**Pre-Preliminary Plan No. 720130040: Potomac Highlands**

**Pre-Preliminary Plan No. 720130040: Potomac Highlands**

**Staff Recommendation:** *Approval with Conditions*

Figure 4 - Pre-Preliminary Plan

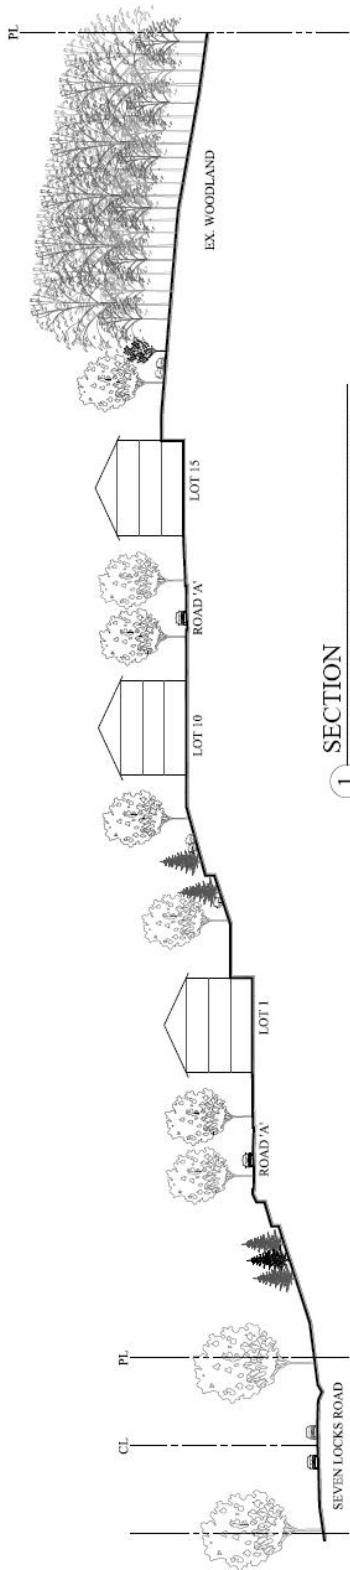
- The application text states that the proposed MPDU units will be similar in width, appearance, height (3 story), and unit type (front load garage) as the market rate units. The text does not comport with the concept plan, which depicts the 4 units as narrower than the market units. This item would need to be addressed at preliminary plan stage.

Figure 9 - Drainage Area

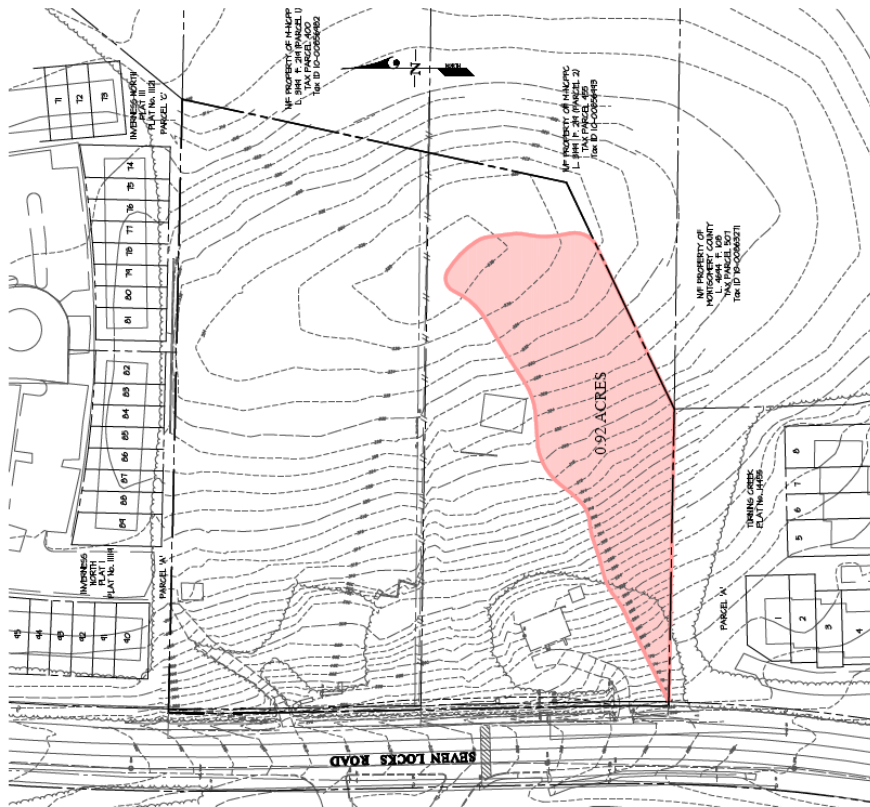
3. Potential increased flooding and erosion on Turning Creek land to the south was a significant issue in 2006. The current applicant has addressed this issue by proposing that the drainage area from the Subject property to the Turning Creek parcel 'A' to the south would be reduced by ninety (90) percent from the present 0.92 acres to 0.09 acres. This would alleviate the situation pertaining today. (Figure 9)
